Particle Measurement procedure for HD Engines

Remark: This working document is based on the PN measurement procedure laid down in UNECE Regulation 49 but should be considered exclusively a technical working document. The purpose of this document is only to discuss within the PMP group the changes/additions needed to modify the PN cut-off size from 23 to approximately 10 nm and to include raw exhaust sampling

TEST PROCEDURE	CHANGES FOR SPN10	CHANGES FOR DIRECT RAW EXHAUST SAMPLING
7.1. Principles of emissions measurement		
To measure the specific emissions, the engine shall be operated over the test cycles defined in paragraphs 7.2.1. and 7.2.2. The measurement of specific emissions requires the determination of the mass of components in the exhaust and the corresponding engine cycle work. The components are determined by the sampling methods described in paragraphs 7.1.1. and 7.1.2.		To measure the specific emissions, the engine shall be operated over the test cycles defined in paragraphs 7.2.1. and 7.2.2. The measurement of specific emissions requires the quantification of the mass or number of components of designated emissions species in the exhaust and the corresponding engin

Figure 21
 Schematic of recommended particle sampling system – Tailpipe sampling (i) without pre-diluter; (ii) with pre-diluter.

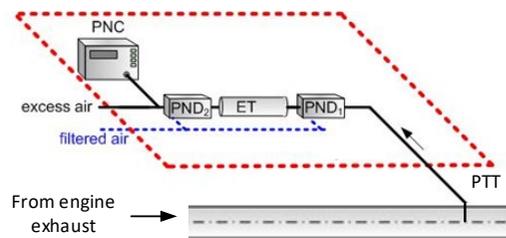
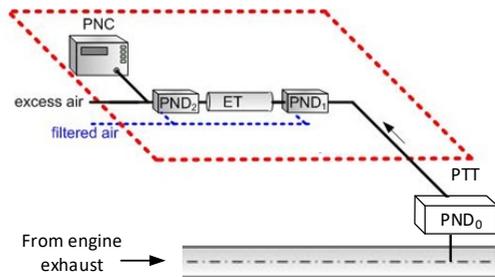
To check if addition of figure number affects other figures numbers
